**RE: Holly Subdivision
Grading and Drainage Plan
Engineer's Stamp Date 6-6-16 (C19D040)**

Re: Holly Subdivision – Grading and Drainage Plan for Grading Permit

CITY OF ALBUQUERQUE
 PUBLIC WORKS DEPARTMENT
 ENGINEERING DEVELOPMENT GROUP
HOLLY SUBDIVISION
 GRADING AND DRAINAGE PLAN

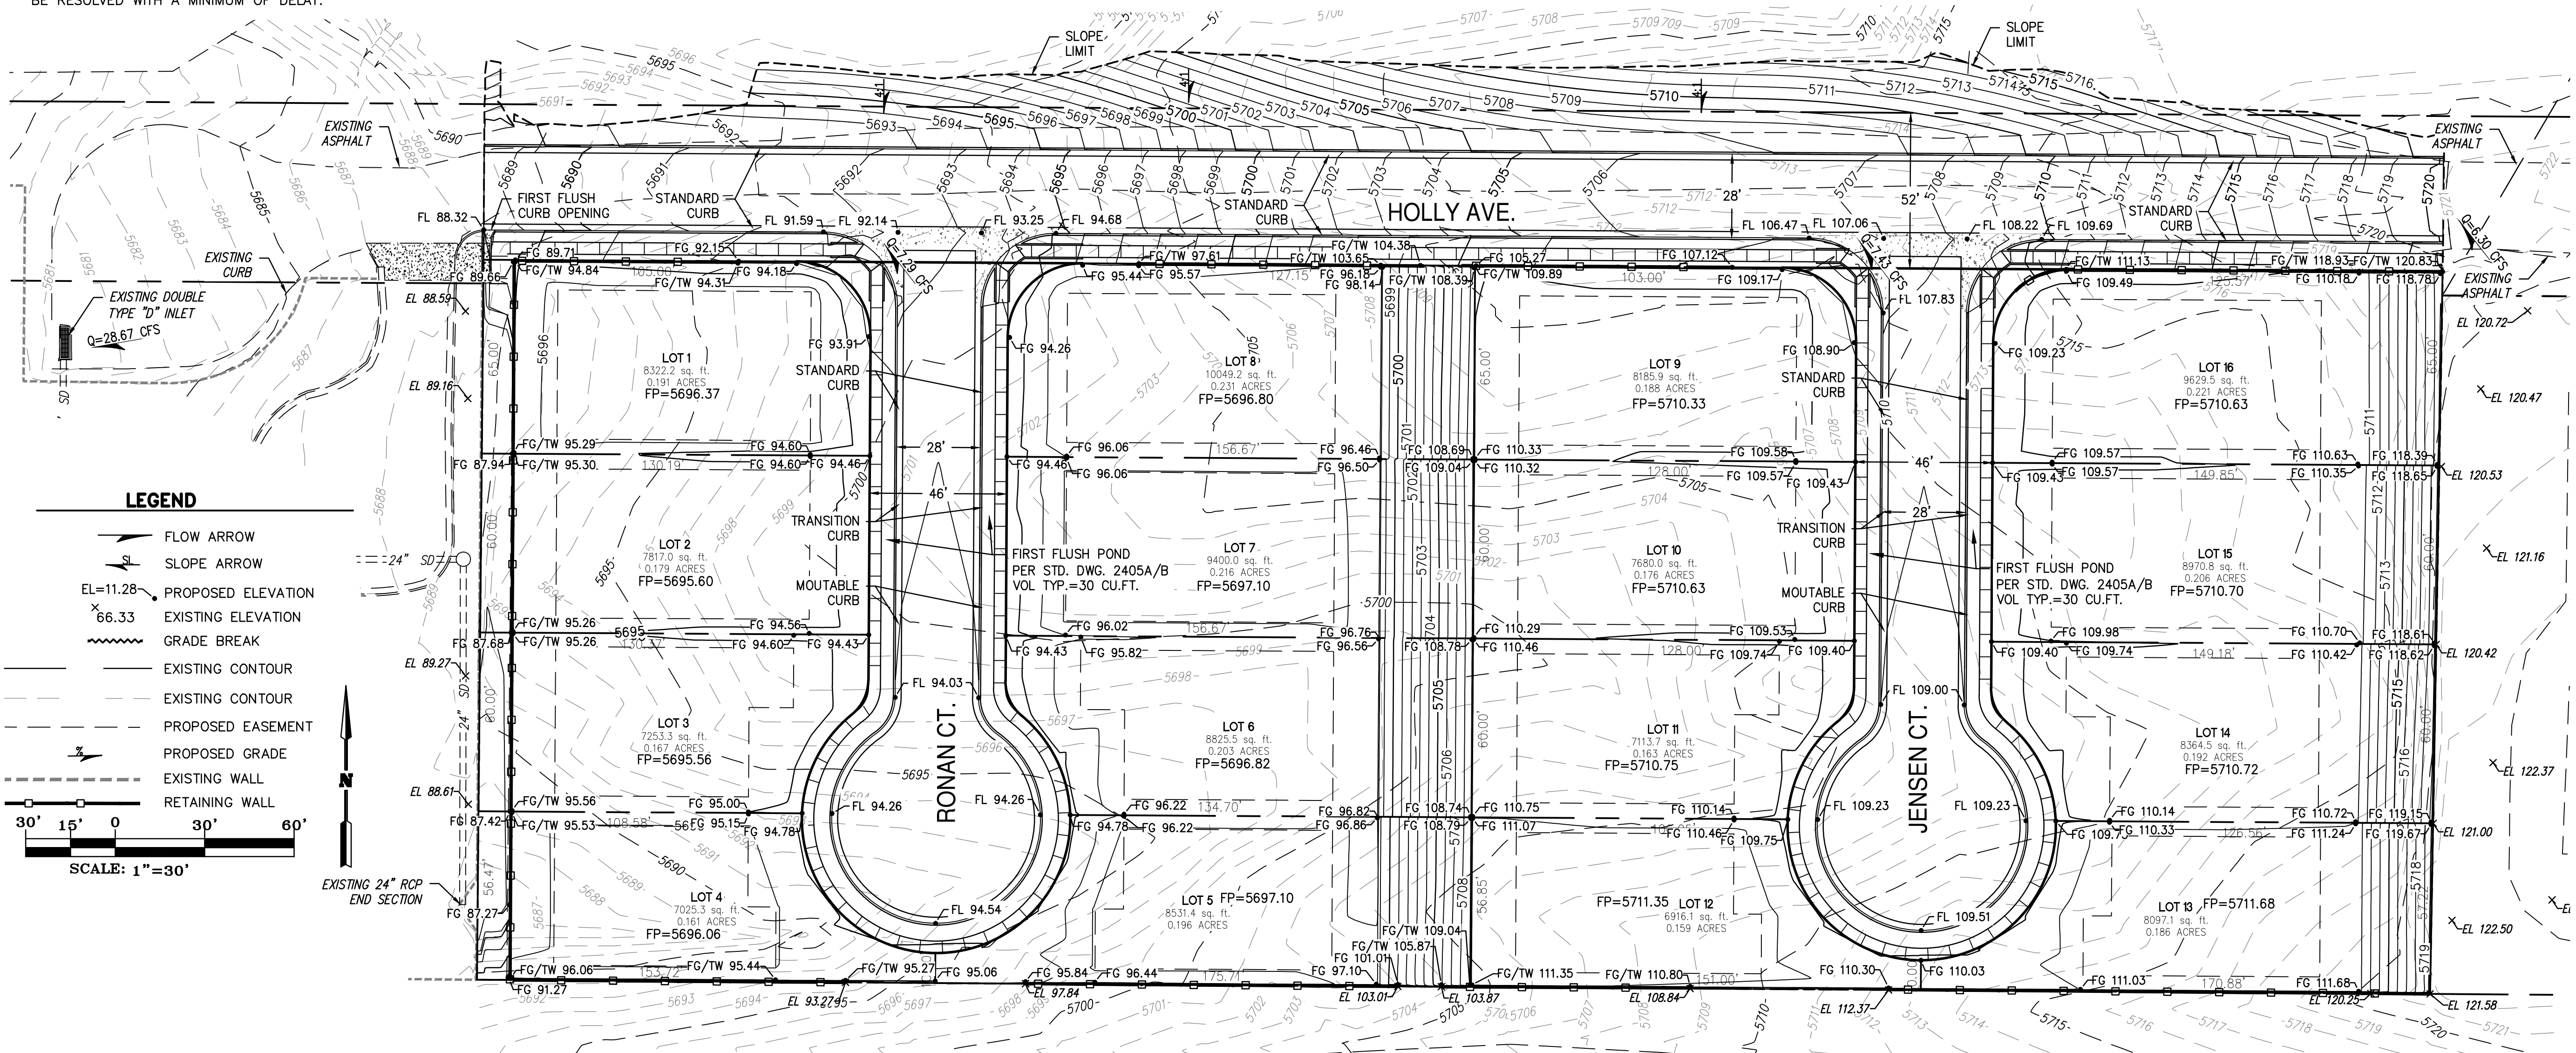
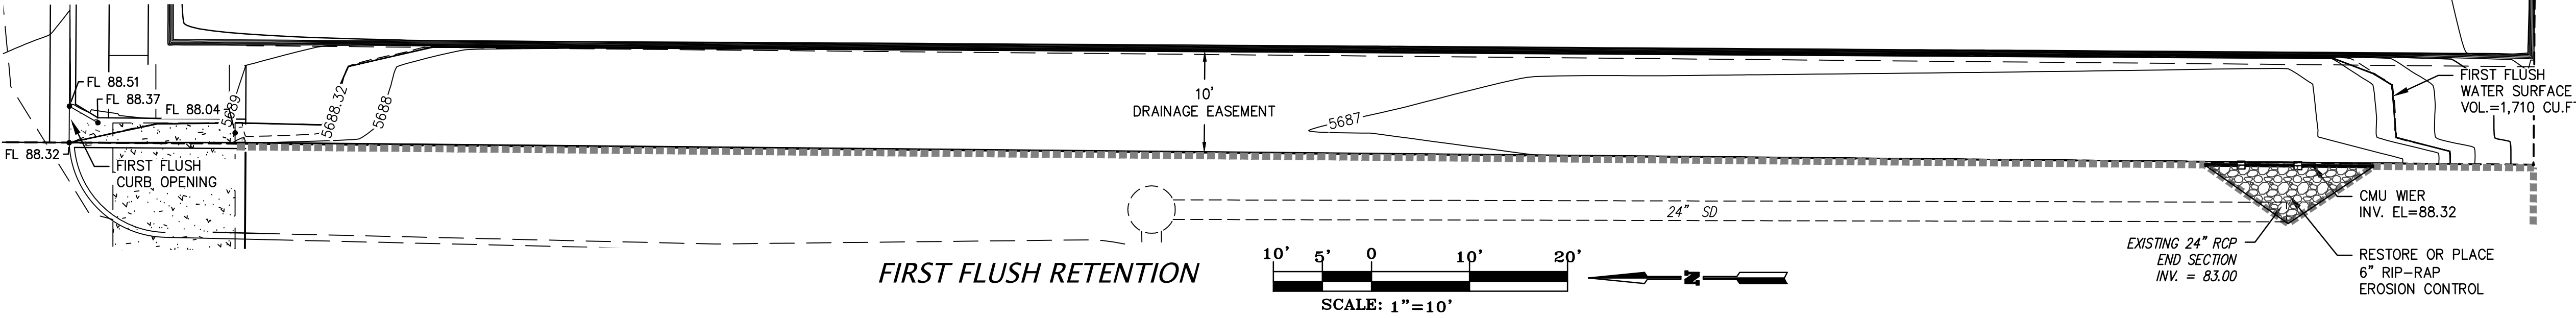
1. *We understand that Parks and Rec and Transportation Development have removed the requirement for a North-South pedestrian path along the west edge of the site; the final plan is expected to have that facility removed.*
The pedestrian access has been removed.

5. *Provide a hydraulic capacity calculation for the mountable curbed streets.*
The curb has been modified to standard curb where necessary to increase capacity.

6. *Provide erosion control (or clean the area if some erosion control exists under sediment) at the entrance to the 24" end section. Since the elevation of the CMU wall opening is set exactly at the same elevation as the opening in the curb, minor field discrepancies in the wall opening elevation can permanently route much of the flow through the first flush pond.*
Erosion control has been addressed on the plan with restoration or placement of rip-rap.

7. *It is assumed that there will be a solid wall between the Church property to the East and this subdivision that will prevent offsite flows, since cross lot drainage easements are not included in the plat. Provide scour protection or grading that prevents erosion at the bottom of the wall.*

Existing grading and drainage improvements along with the vegetation of the adjacent site currently prevent flows from entering the lots and provide adequate erosion control.
